Re: Comments on "Feasibility Study" and "Proposed Plan for
Remediation", Tutu Well Site, St. Thomas,
Virgin Islands

COMMENTS ON FEASIBILITY STUDY AND PROPOSED PLAN FOR REMEDIATION
TUTU WELL SITE, ST. THOMAS, UNITED STATES VIRGIN ISLANDS
SUBMITTED ON BEHALF OF L'HENRI, INC.

Comments
Final Remedial Investigation (RI) Report
Tutu Wells Site, Tutu, St. Thomas
Report Prepared by Geraghty and Miller (April 1995)
Comments by IT Corporation for L'Henri Inc. (June 7 1995).

Figure S-27

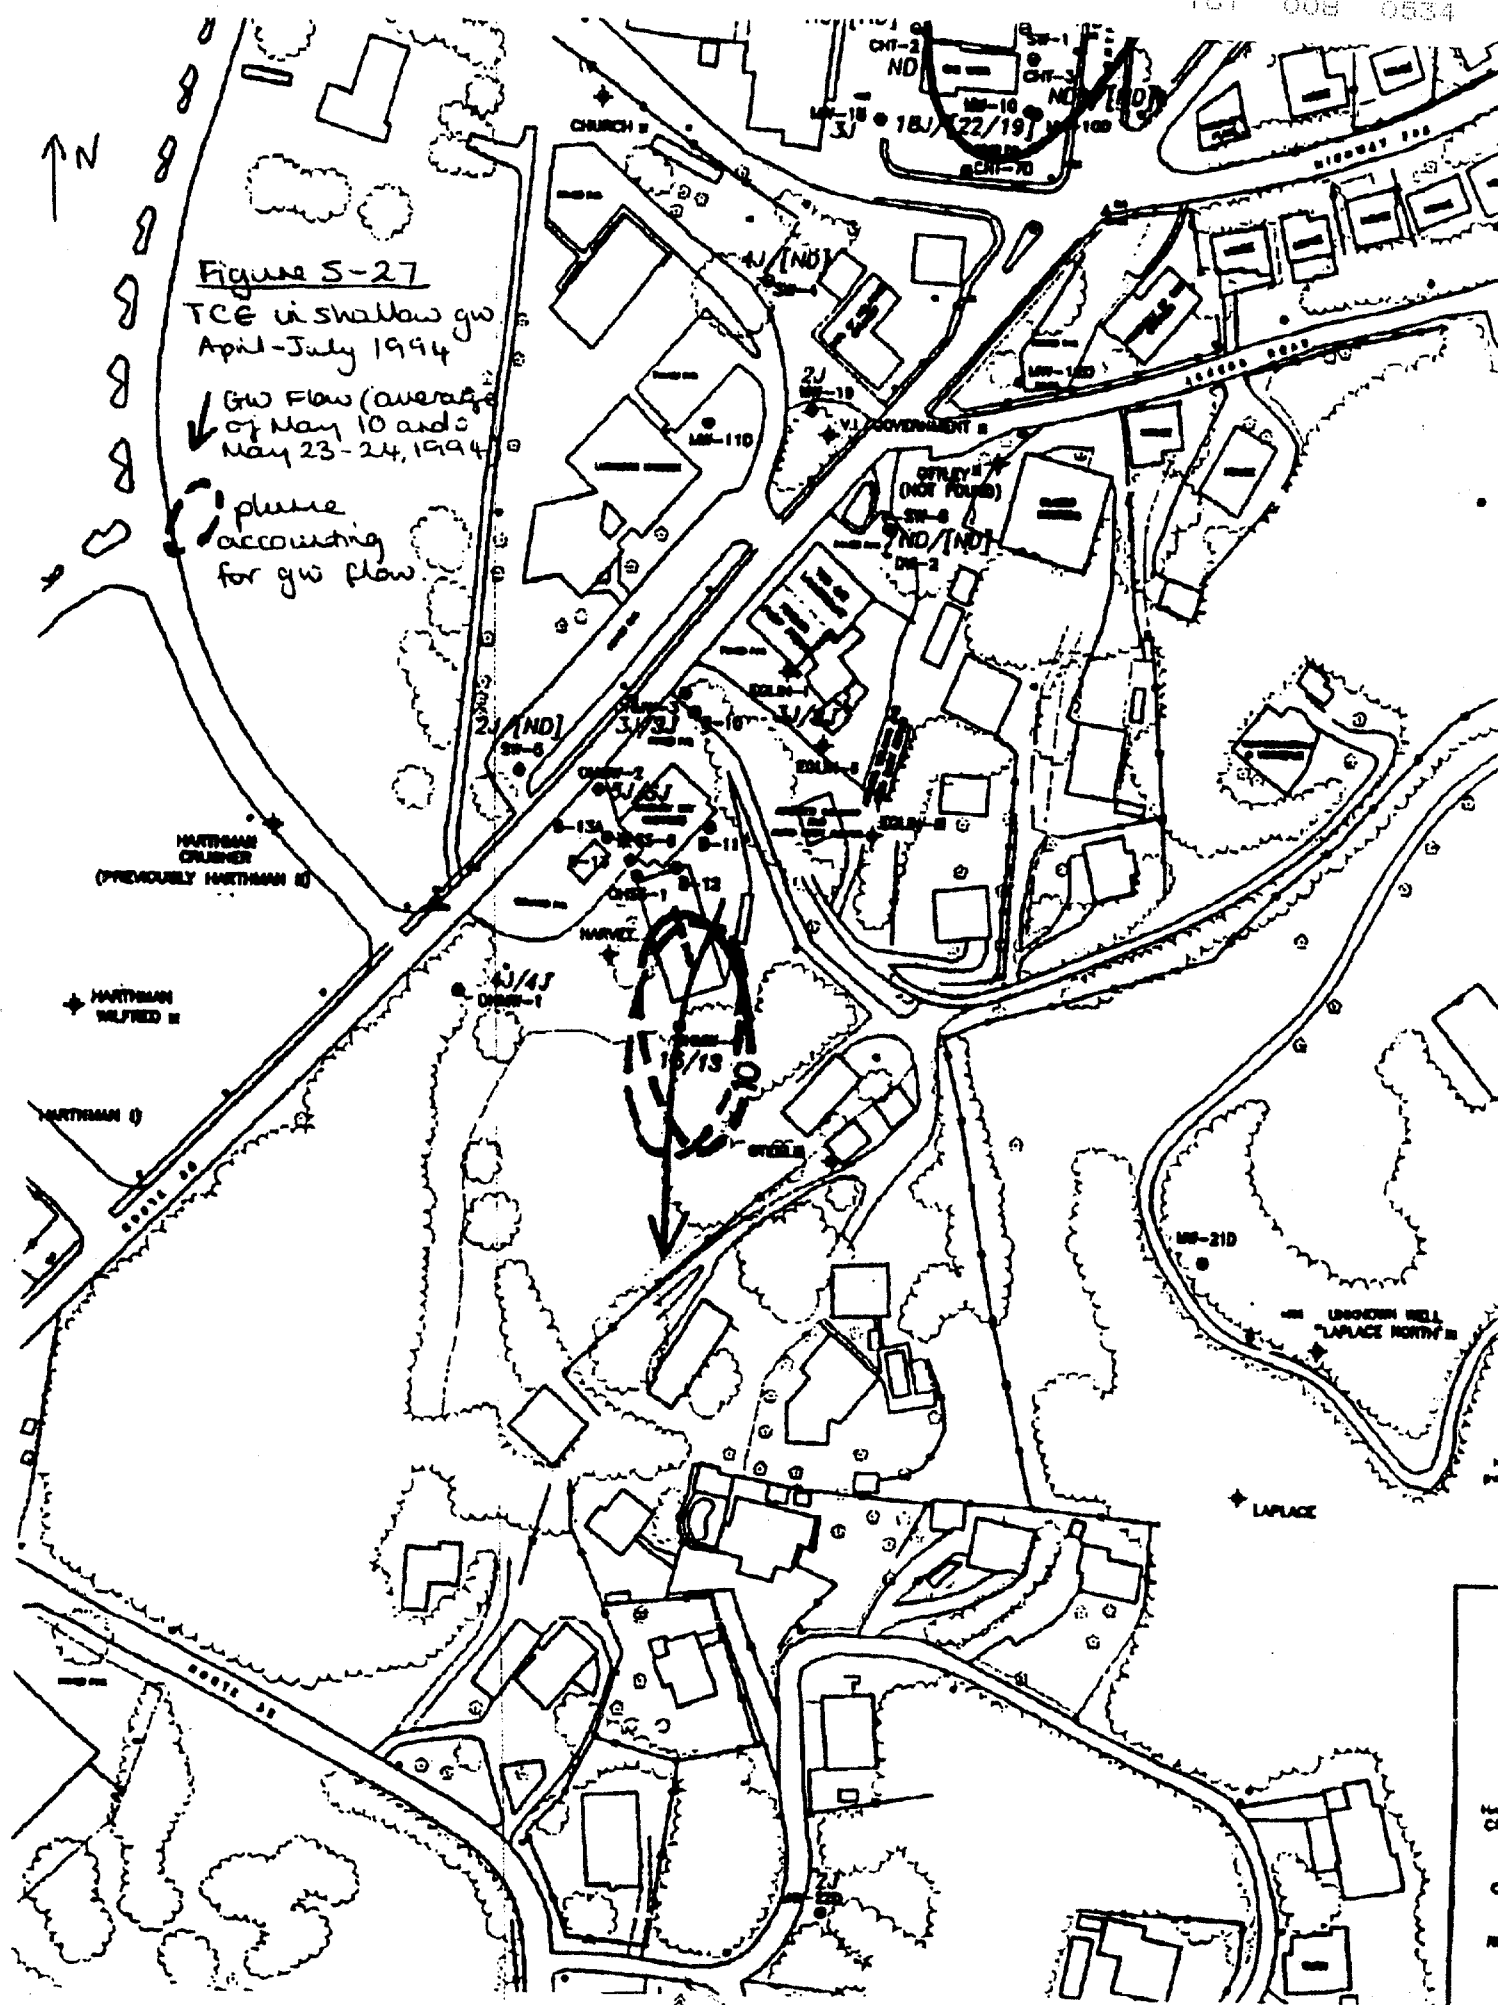
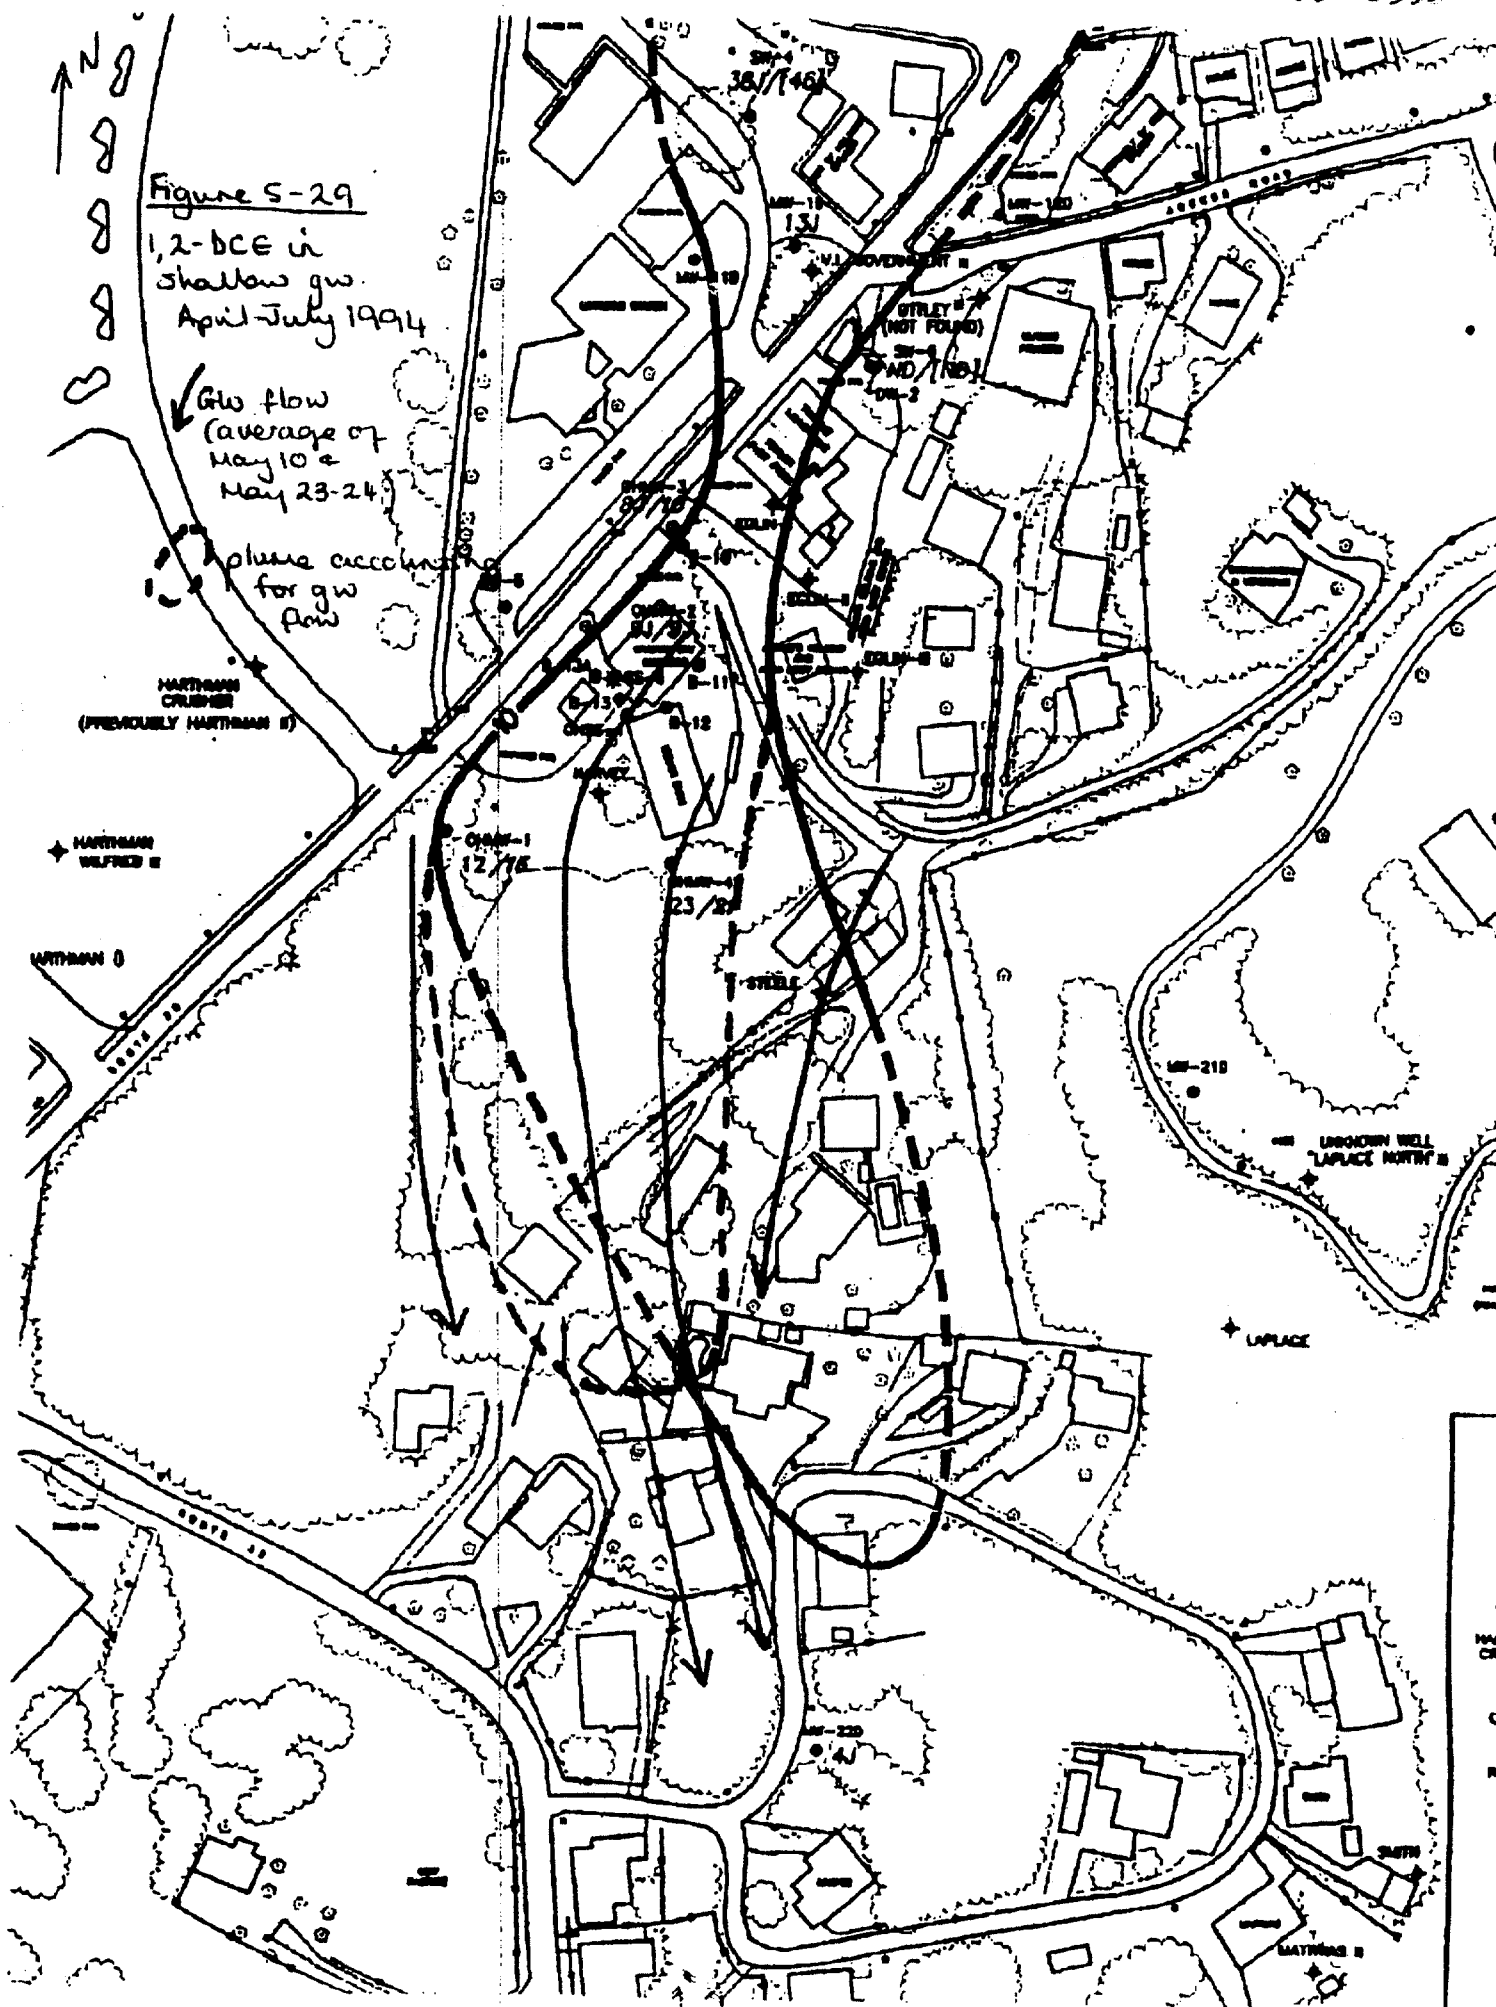
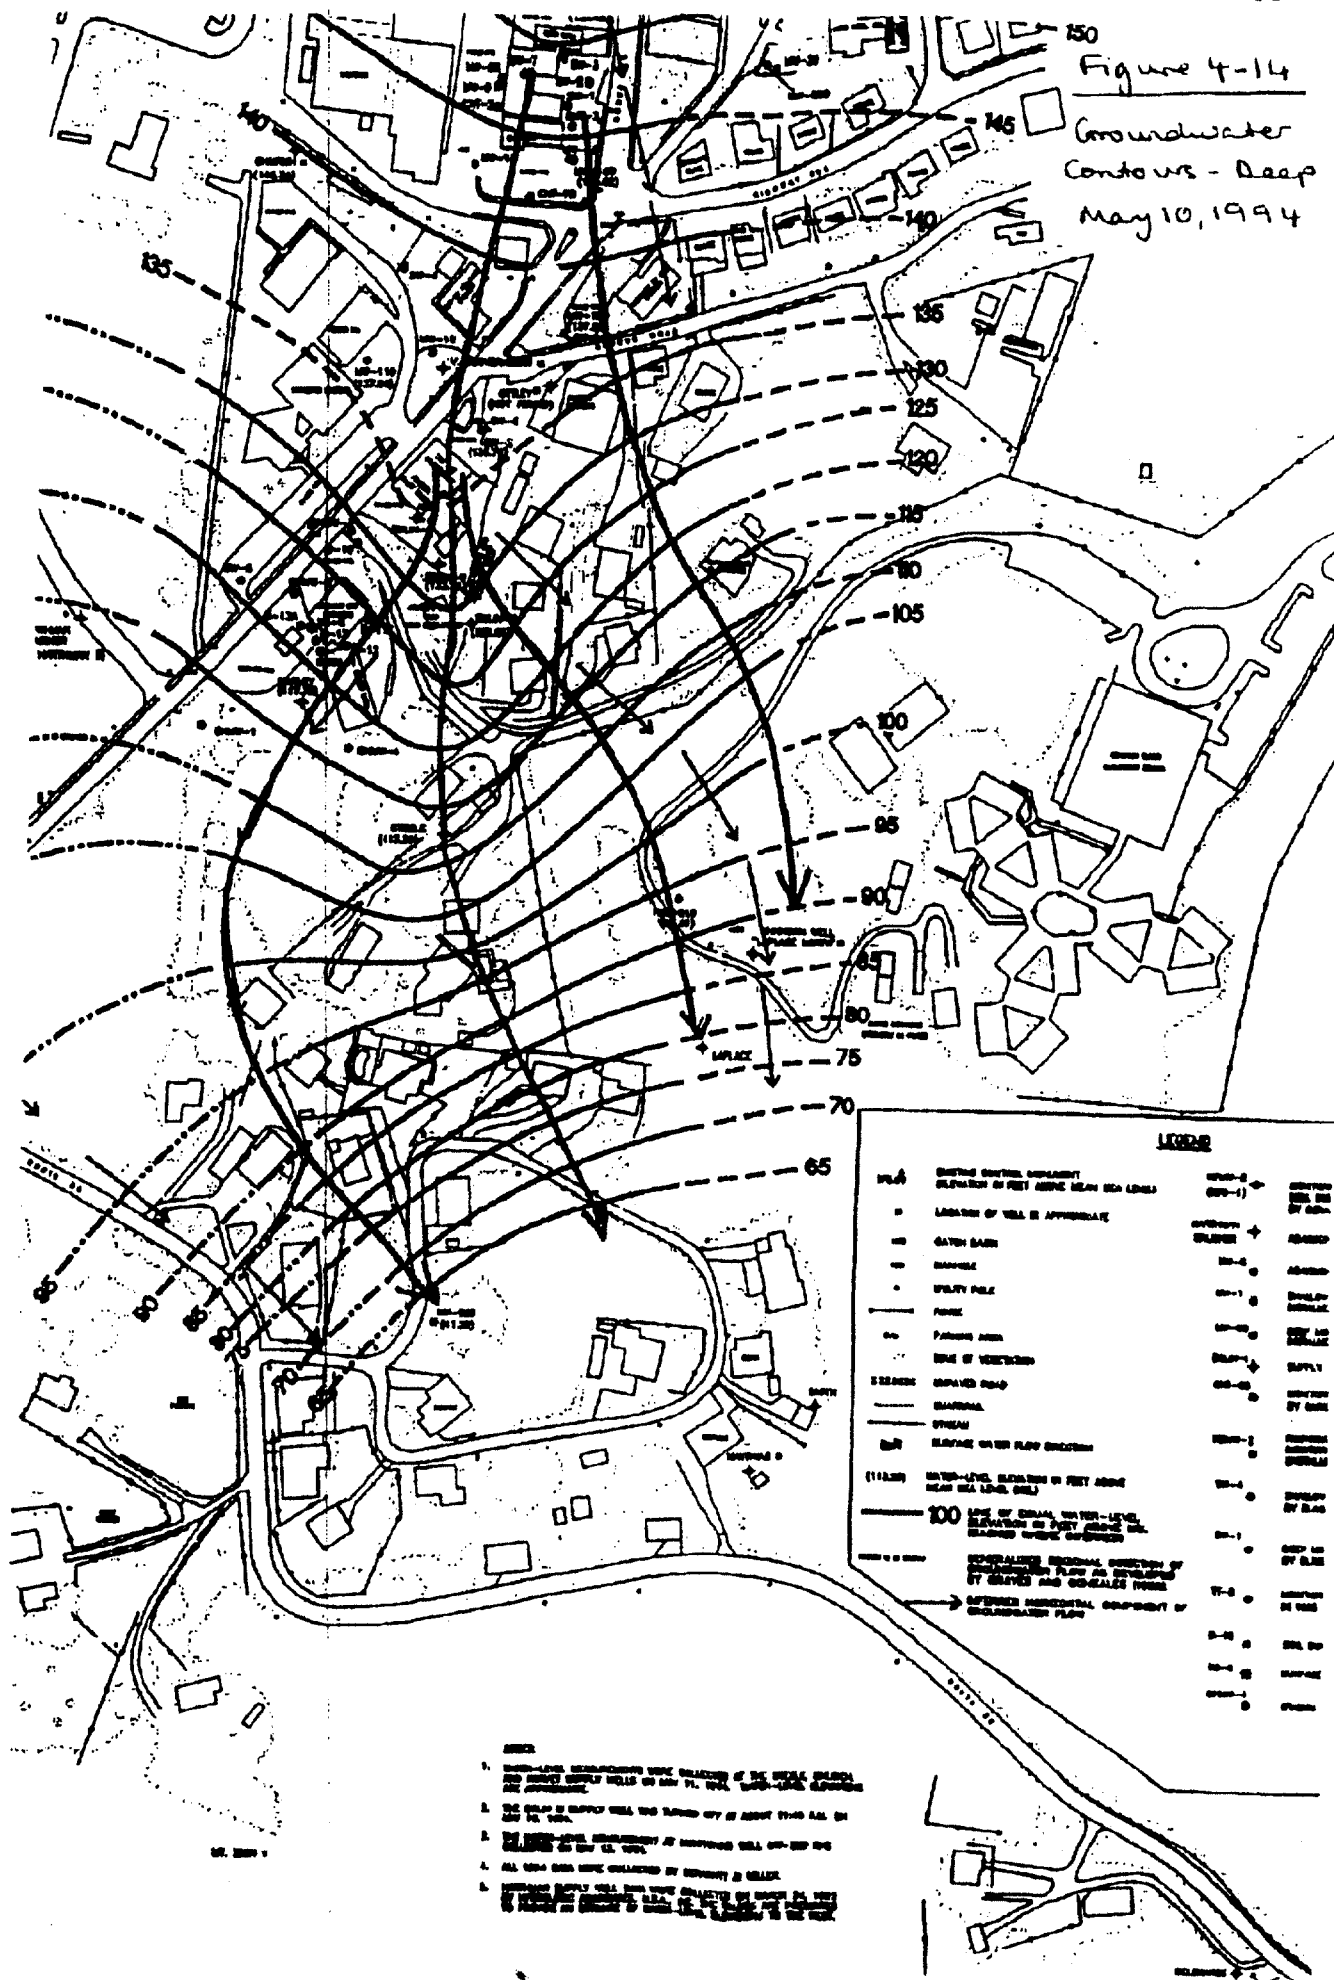
plume
accounting
for gw flow

Figure S-26

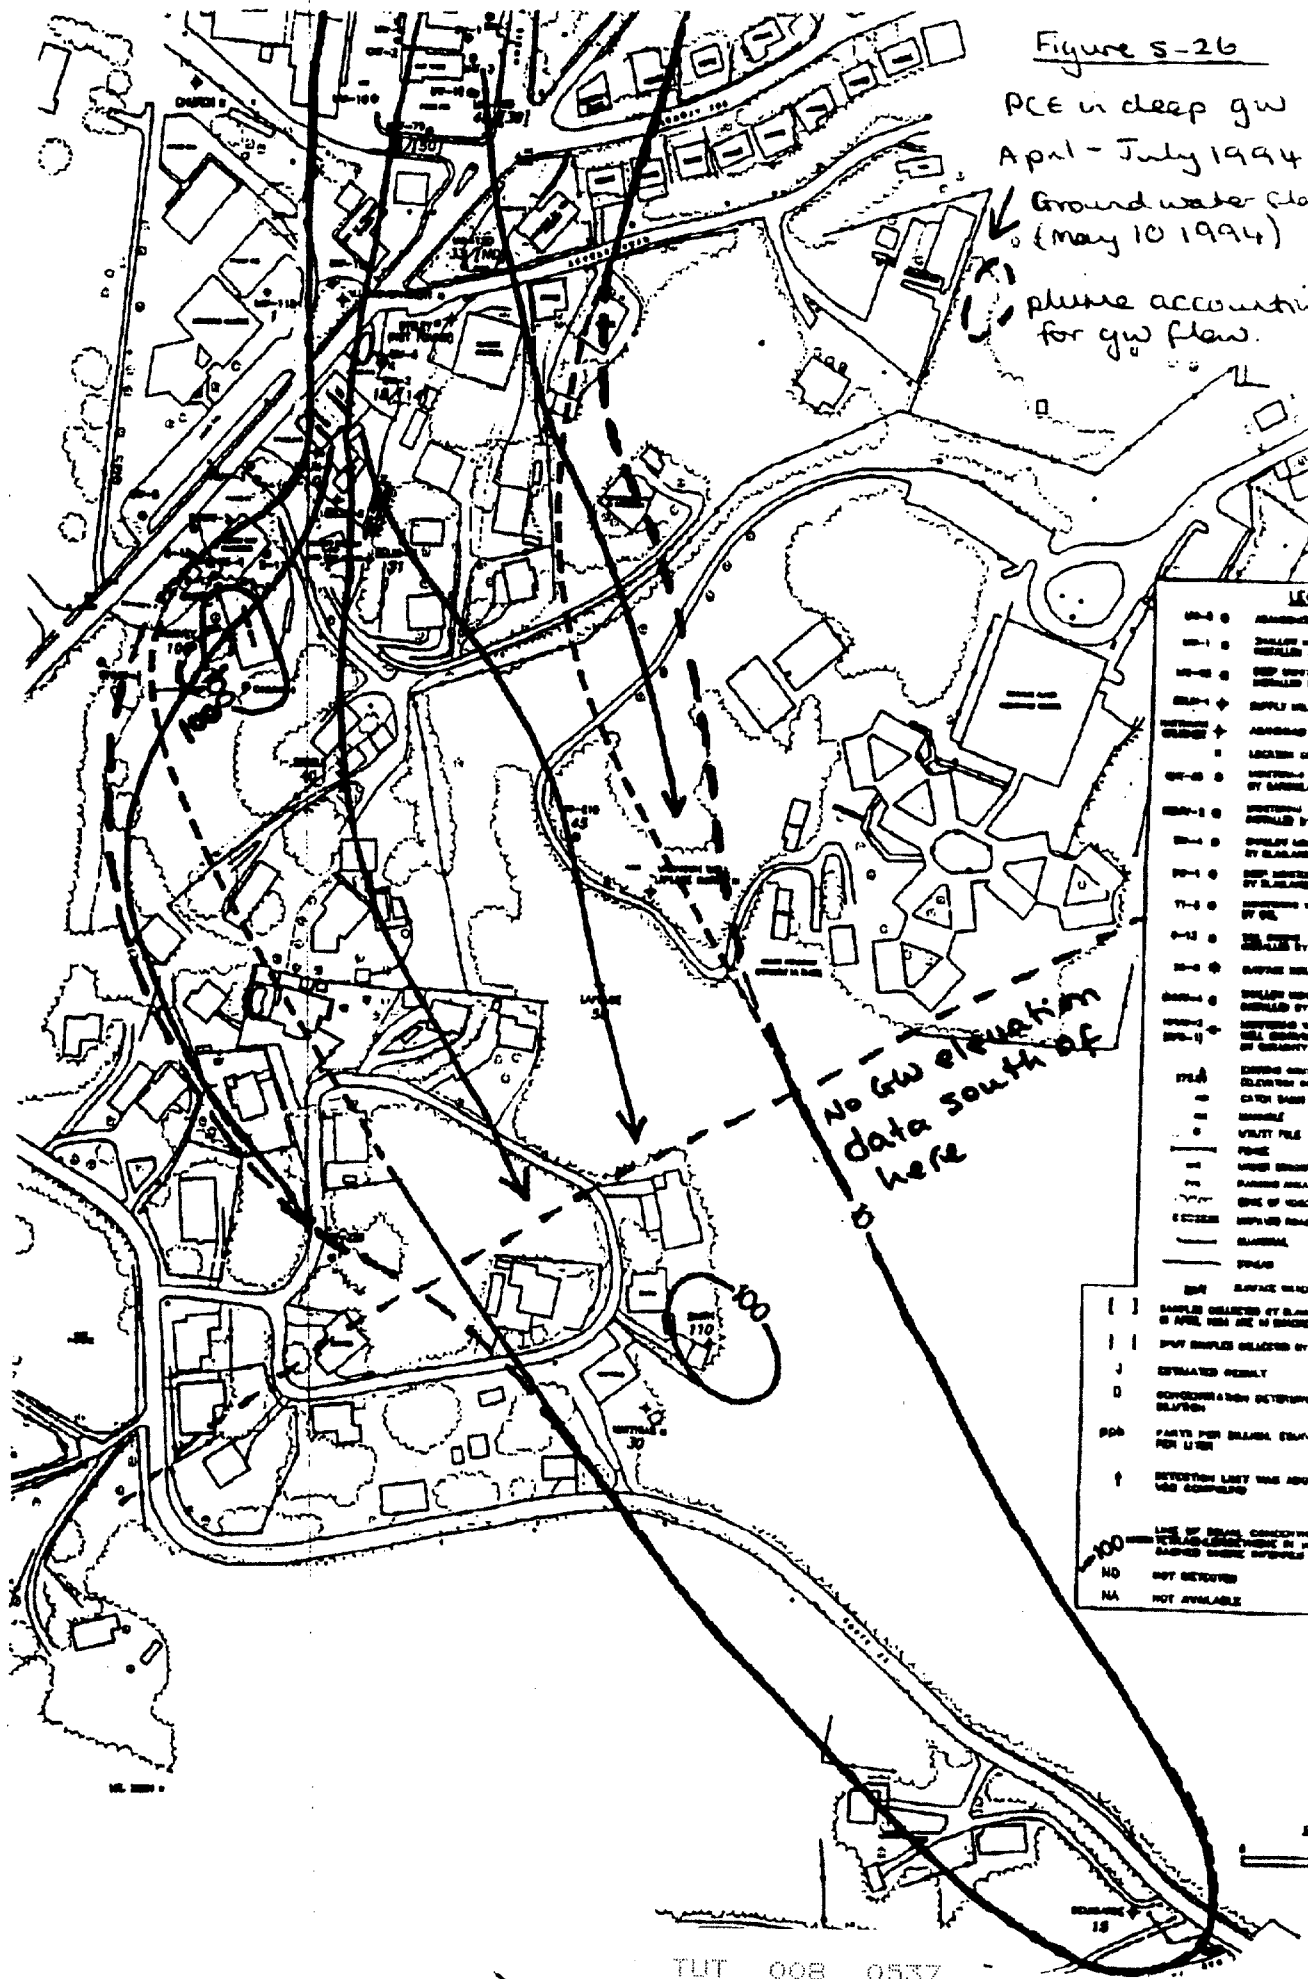
please account for gw flow.
